E8363B-08 <u>S E R V I C E N O T E</u>

E8363B PNA Microwave Network Analyzers

An enhancement added to absorb vibration when opening the swing deck during hardware repair.

Figure 1

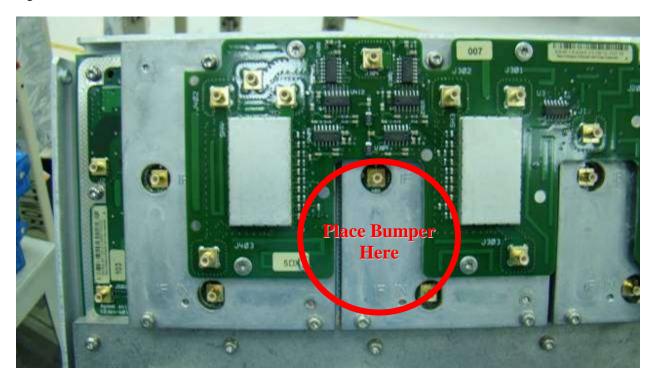
A rubber bumper – E8361-40001 is available to improve the serviceability of the instrument. This will also ensure the swing deck well separated from other nearby assembly.

- 1. Go to http://na.tm.agilent.com/pna/documents.html.
- 2. Click on the appropriate Service Guide.
- 3. When the PDF of the Service Guide is displayed, look at the bookmarks in the left column. Expand the Contents section by clicking on the plus sign next to its bookmark.
- 4. Scroll through the Contents section bookmarks to locate "Repair & Replacement Procedures."
- 5. Click on the title/hyperlink for the section "Receiver Deck."
- 6. Follow the instructions in the subsection "Raising and Lowering the Receiver Deck."
- 7. Once the Receiver Deck has been lower, installed the Bumper as shown in Figure 2.
